5440 WADE PARK BLVD, SUITE 102 WWW.BGEINC.COM NC LICENSE #C-4397 ©2023	DESIGNED BY:				
	DRAWN BY:				
	REVIEWED BY:		DF		
			DF/JWM	10/02/2023	PER TOWN OF ROLESVILLE COMMENT
				08/01/2023	PER TOWN OF ROLESVILLE COMMENT
		REV	06/01/2023	INITIAL SUBMITTAL

PARKER RIDGE
82 SCHOOL STREET
ROLESVILLE / NORTH CAROLINA / 27571

CARVED STREET CT PLAN
AND PROFILE

LONG MELFORD DRIVE PLAN
AND PROFILE (1 OF 5)

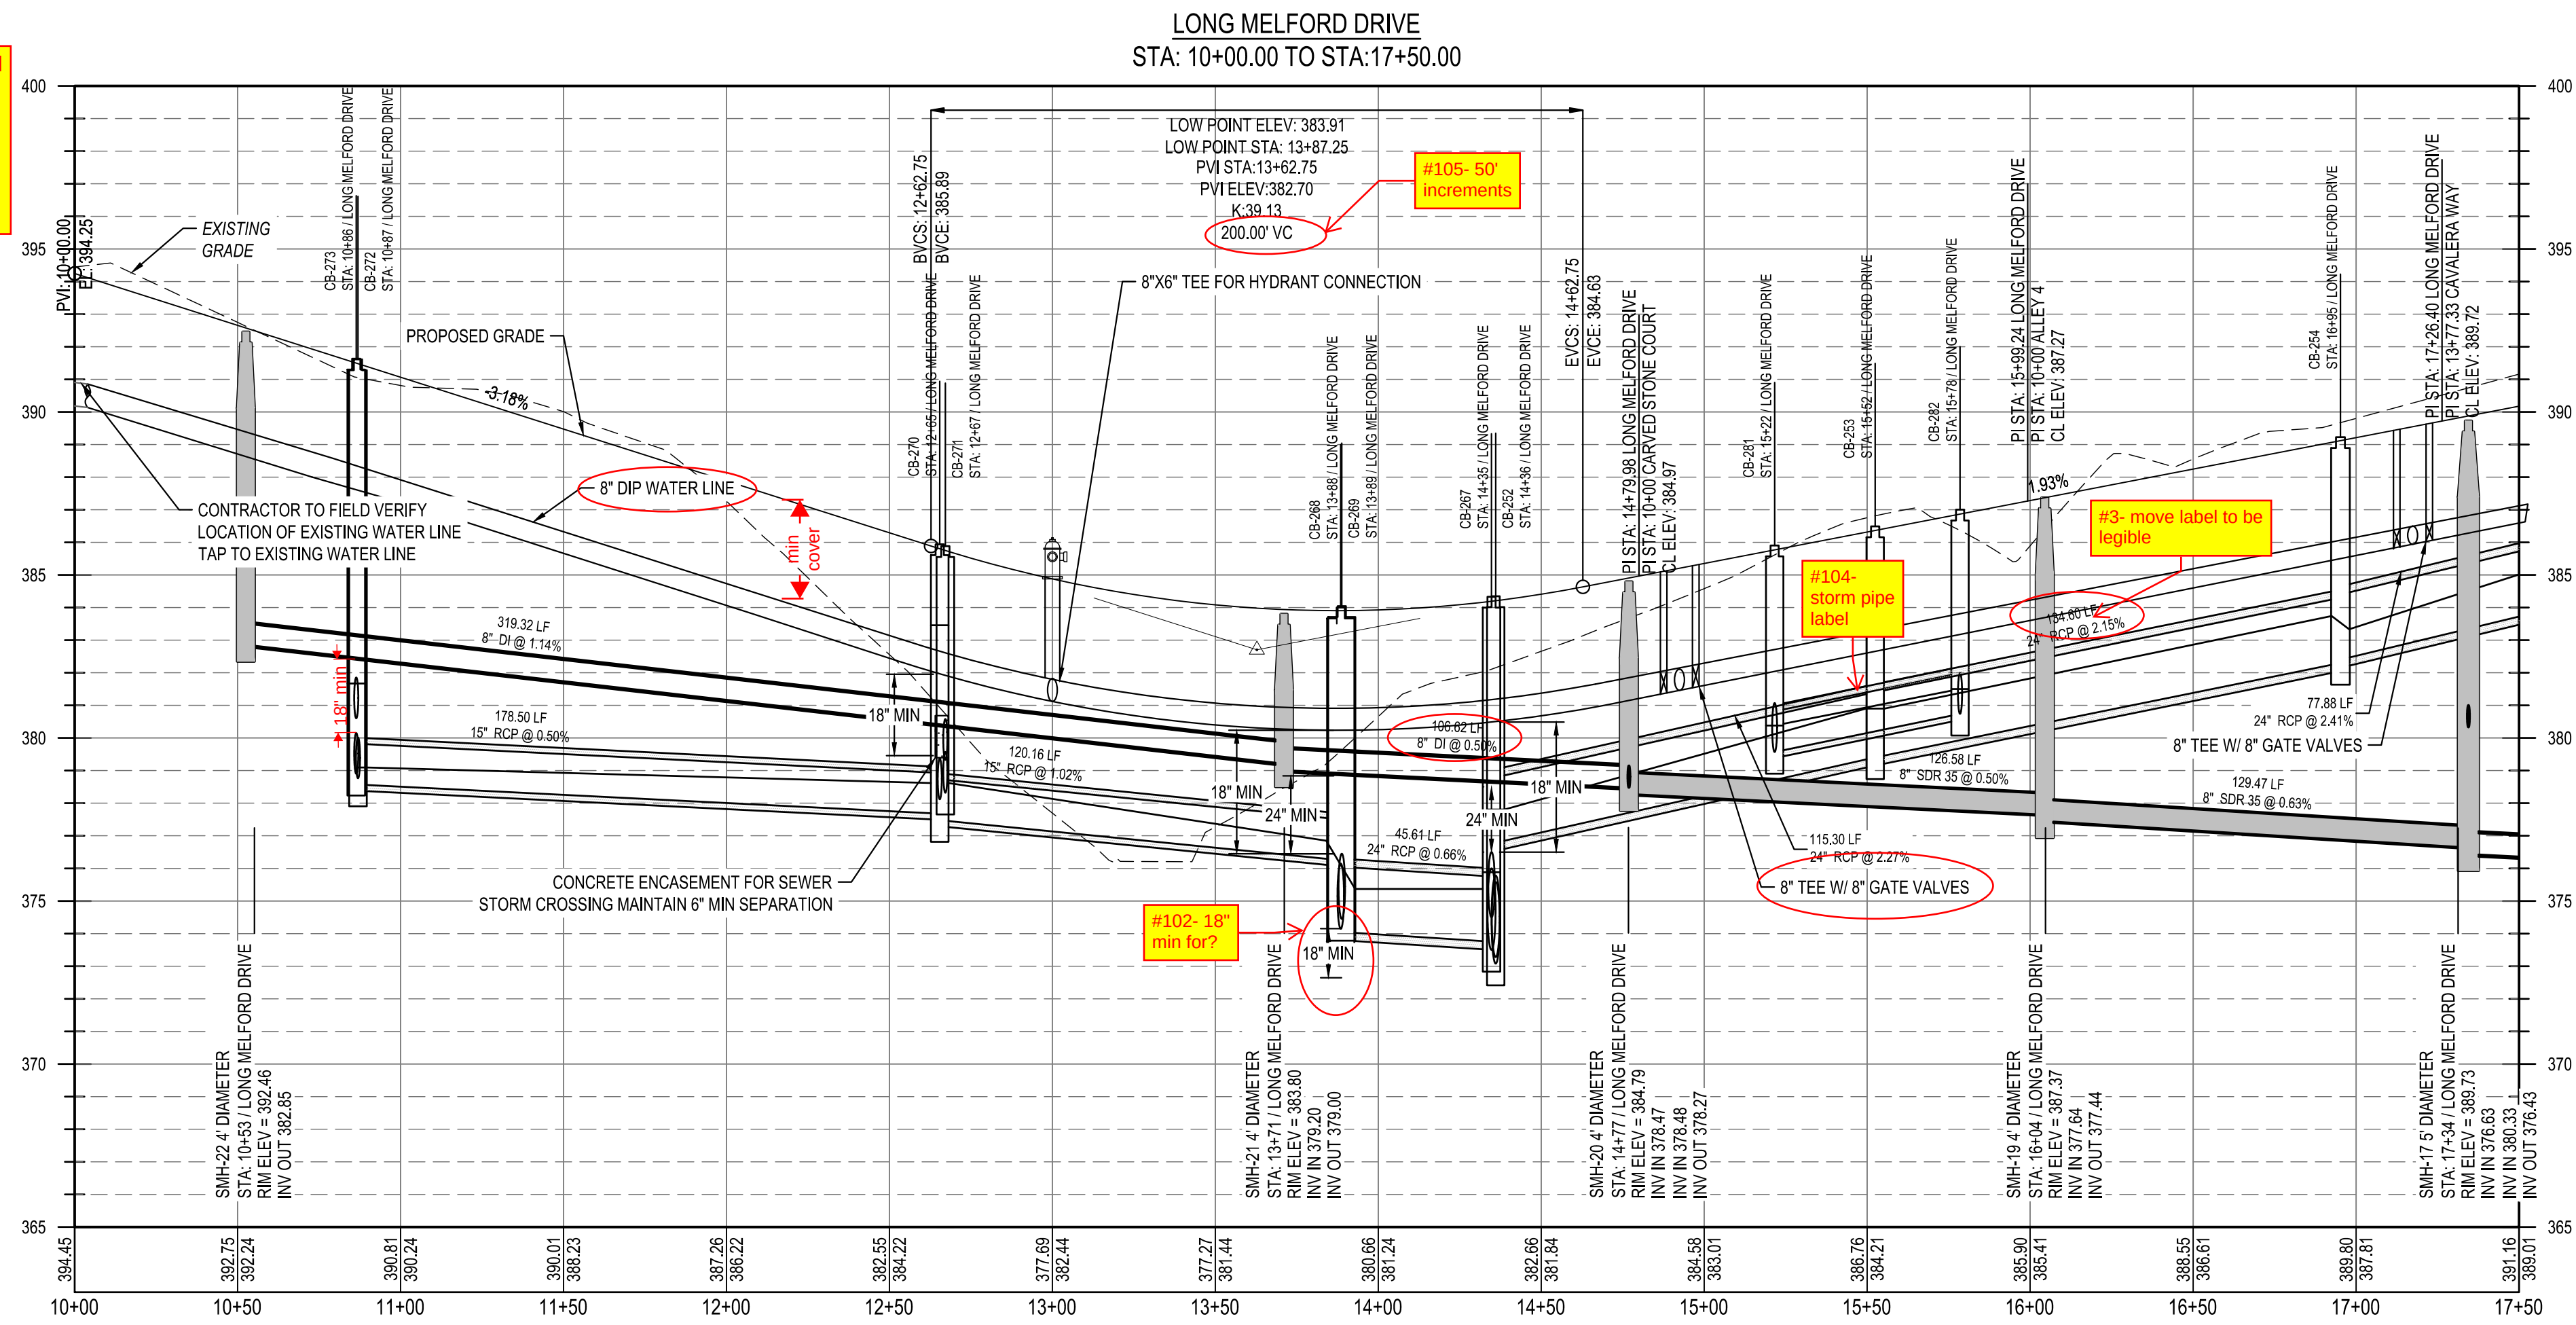
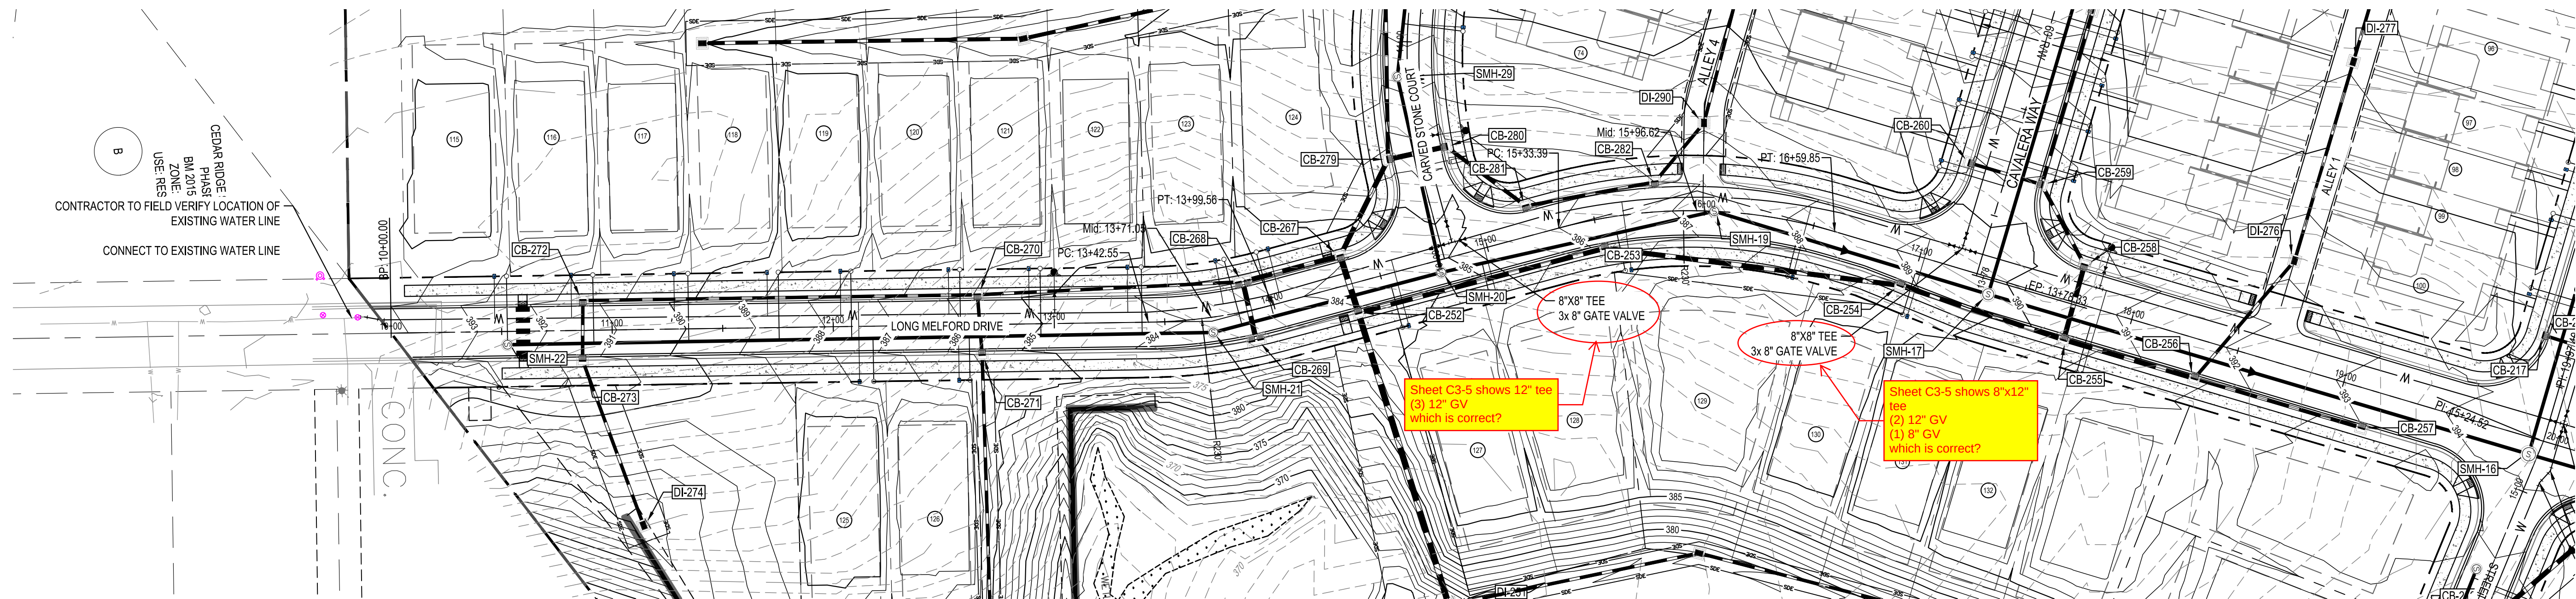
#23- There are several instances where water line, tees/crosses, and valve sizes differ between Utility plan sheets and Plan and Profile sheets. Please make the necessary adjustments to ensure that water lines, connections, and valves correct sizes remain consistent throughout all sheets.

#102- Make sure dimensions are in the correct locations and it is clear what is being dimensions. Some dimensions don't seem to line up with top/bottom of pipes. If crossings do not meet minimum requirements, the design will need to be adjusted. Minimum separation requirements should be shown at all pipe crossings. This comment applies to all profile sheets.

G:\INCA\Projects\Lennar\8430-03 - Lennar - School Street - Rolesville\03 - DWG\PlanSheets\On-Site\C6-10 ALLEY PLAN AND PROFILE.dwg Layout: C6-15 ALLEY 2 PLAN AND PROFILE Plotted: 10/12/2023 4:03:37 PM

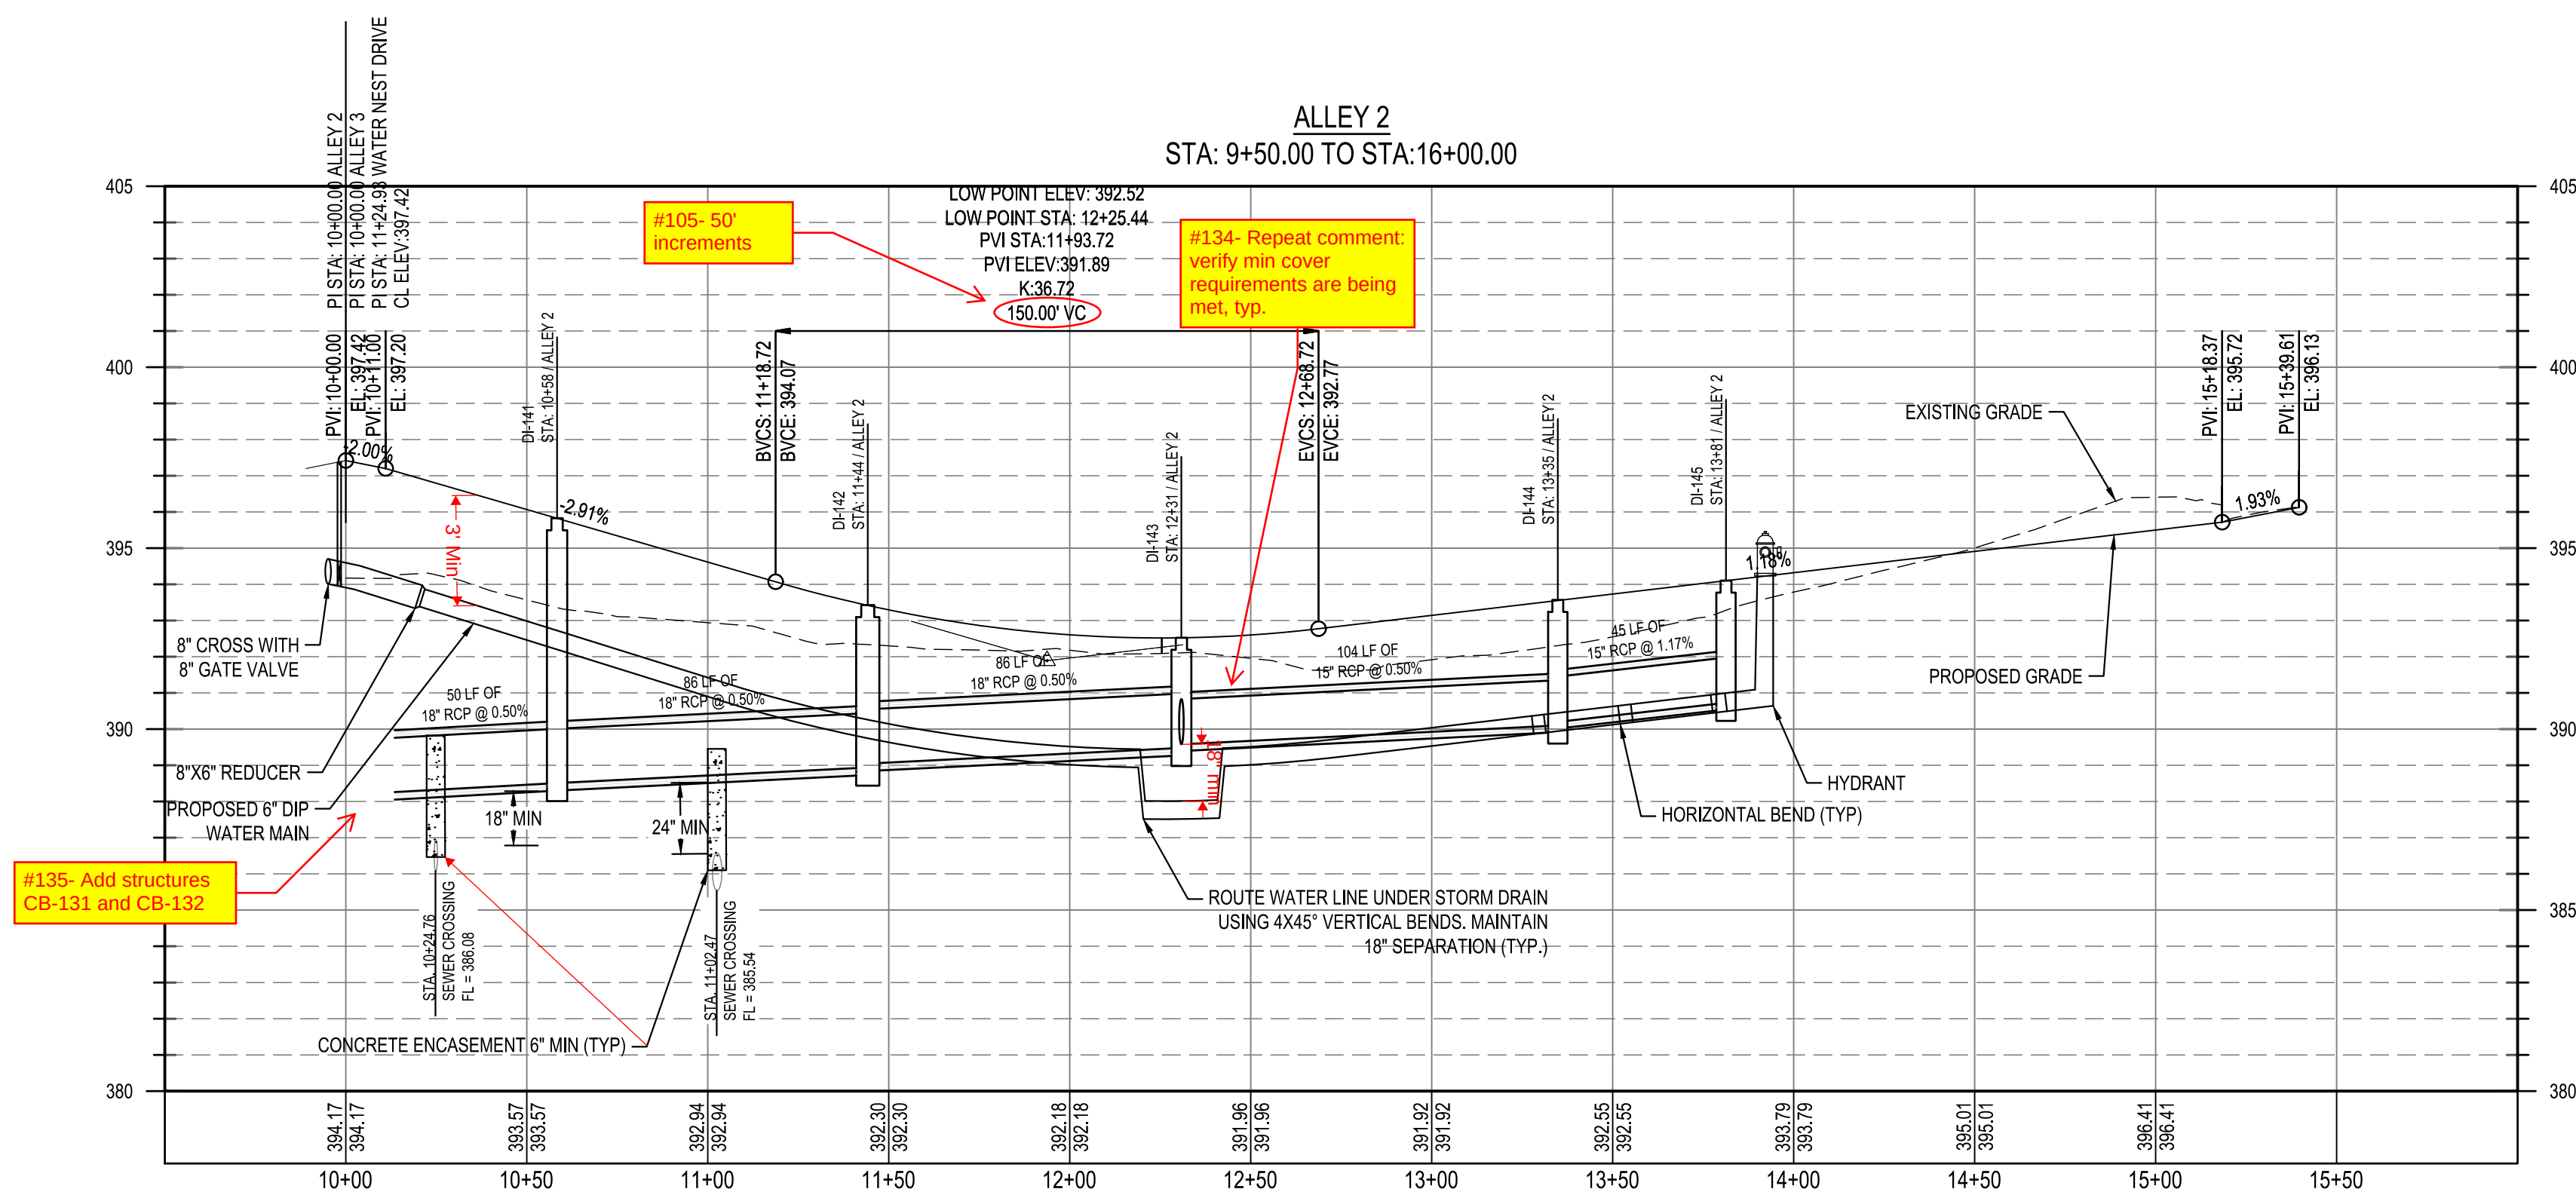
#102- Make sure dimensions are in the correct locations and it is clear what is being dimensions. Some dimensions don't seem to line up with top/bottom of pipes. If crossings do not meet minimum requirements, the design will need to be adjusted. Minimum separation requirements should be shown at all pipe crossings. This comment applies to all profile sheets.

#104- Label cross and reducer

#3- Flip label
